Functional Differences Between Masks 3F48S and 2K30A of the DSP56301

This document describes the differences between masks of the DSP56301: mask 2K30A and the preceding mask 3F48S. The newer 2K30A mask uses the communications design rules (CDRII) process. The 2K30A mask set also has new I/O and a new PLL, with the requisite change in the PLL capacitor equation (PCAP).

Figure 1. Operating Mode Register (OMR)

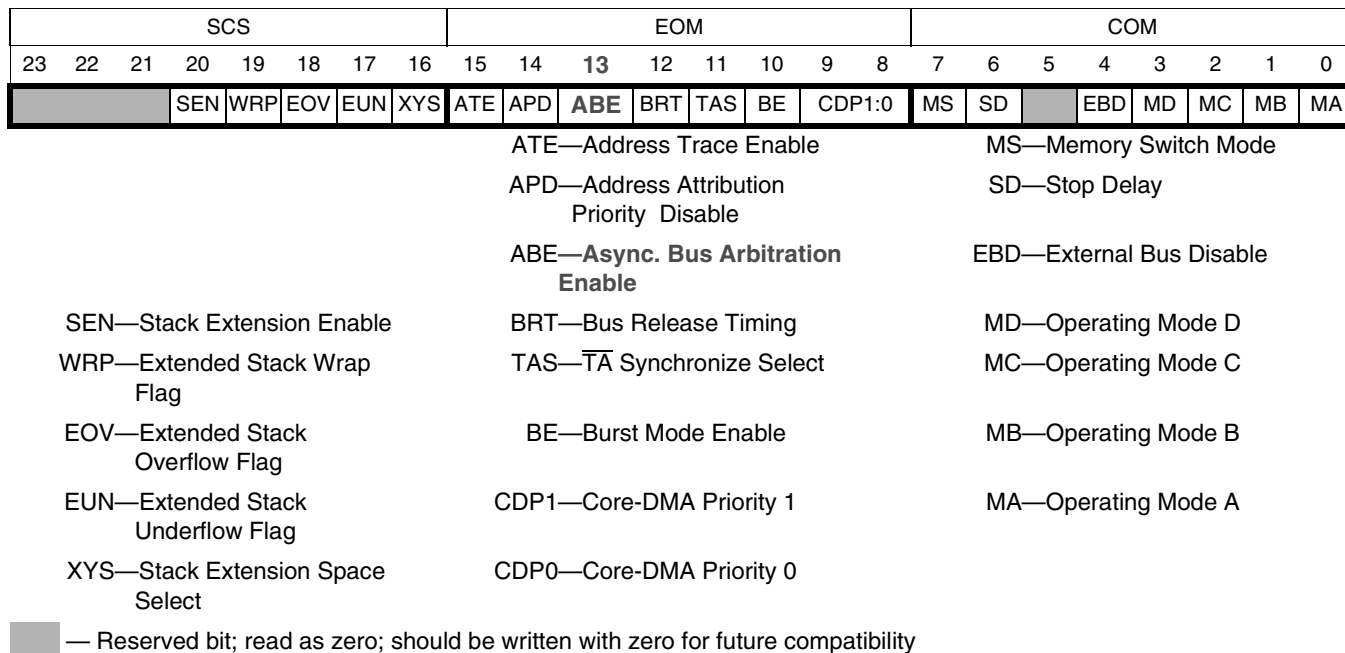
In the Operating Mode Register (OMR) of the 2K30A is a new Asynchronous Bus Arbitration (ABE) bit to support external access at high frequencies. As **Figure 1** shows, bit 13 in the OMR enables Asynchronous Bus Arbitration. For convenience, **Table 2** defines all the OMR bits available in the 2K30A mask set of the DSP56301. The new ABE bit is highlighted in a bold red font.
